From: [Avitabile, David](#)
To: ["Ndaw, Mamadou \(DCRA\)"](#)
Cc: ["Ilan Scharfstein"; Epting, John](#)
Subject: FW: 2121 M Street -- Review of our discussion
Date: Friday, November 22, 2013 12:20:04 PM
Attachments: [2121M Roof Plan.pdf](#)

HYATT PLACE HOTEL

2121 M St. NW, Washington DC 20036

ROOF TERRACE

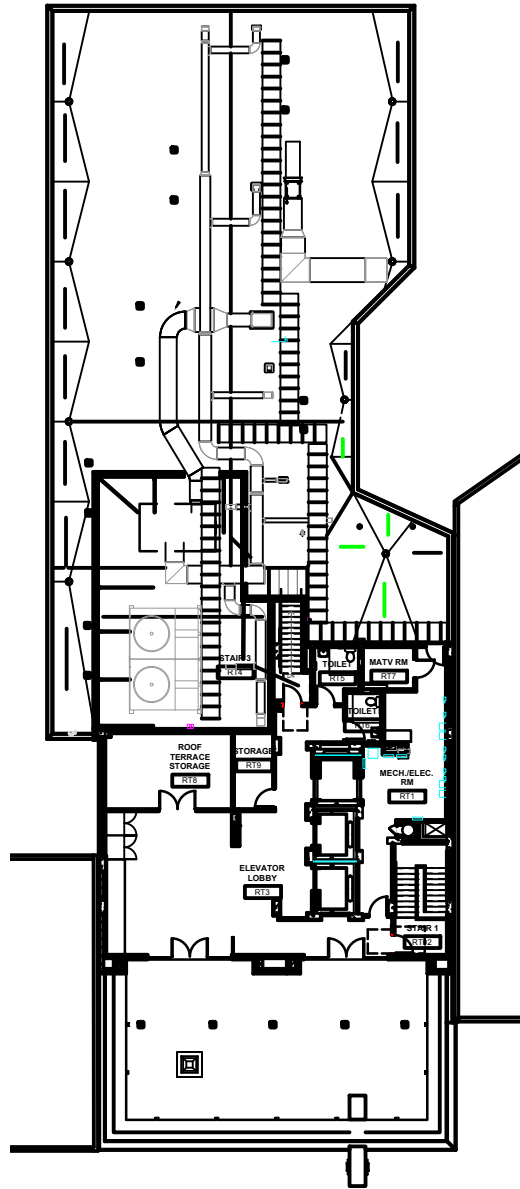
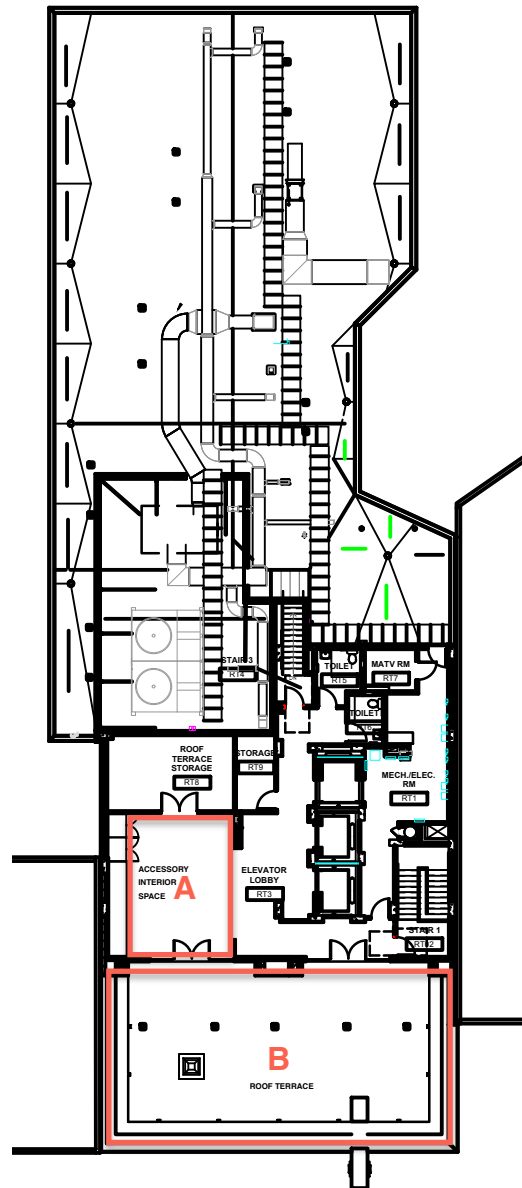
Please see attached for the whole roof plan and then a second page outlining the outdoor terrace and the interior accessory space. The outdoor terrace (B) is 1,687 s.f., and the interior space (A) is 480 s.f. This means that the interior space is 28-29% of the exterior space – however, our client noted that this is a function of the lot size and building configuration, which limits the size of the exterior space. In the absolute, the 480 s.f. interior space is small.

- 1- Do you have an image of the entire roof and the structures on it?
- 2- What is the percentage of the accessory interior rooftop penthouse space compared to the outdoor roof area that it serves?

- As we discussed, the proposed Project contains a roof structure that is set back from all exterior walls (that is, the south wall that faces M Street and the north wall that faces the open court). No setback is required from the east wall, which is a lot line wall that abuts another 90-foot tall building, or from the west wall, which faces a closed court within the single record lot.
- Pursuant to our discussion, we have modified the roof structure to reduce the amount of accessory space within the structure and clarify that the enclosed space is intended to be used for uses that are accessory to the rooftop recreation space , as shown on the attached plan. Please confirm that the revised roof plan is acceptable.

Thanks for the clarification, as well as illustrative plans that were attached to your email. By this email I am confirming my agreement with its analysis, and its conclusion that the areas of the rooftop structure comply with Section 411 of the Zoning Regulations.
